November 10, 2021

**ADDENDUM NO. 03**  
**TO**  
**SPECIFICATIONS AND CONTRACT DOCUMENTS**  
**FOR**  
**INVITATION TO BID**  
**TMT WAREHOUSE #1 RE-ROOF**  
**JPA CONTRACT NO. C-1631A**

4 X 8 BOARD PATTERN

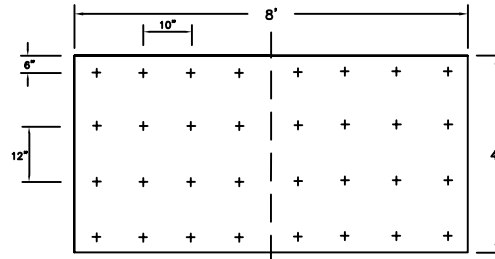
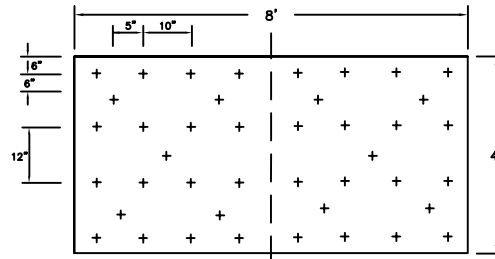
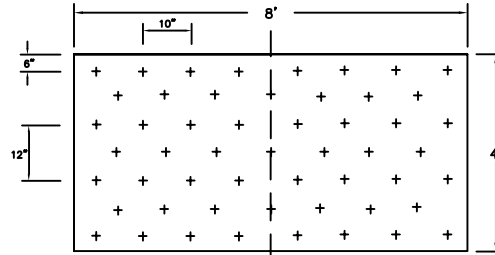
Clarification to quantity of fasteners required per board/zone per The Garland Company, Inc. Cover Board and Anchor Sheet 32-48-64 PER BOARD, shown as **Attachment No. 1** (4' x 8' Board Pattern) is the preliminary fastening pattern provided by Garland for the simultaneously fastening of the cover board and anchor sheet per the specification for reference.
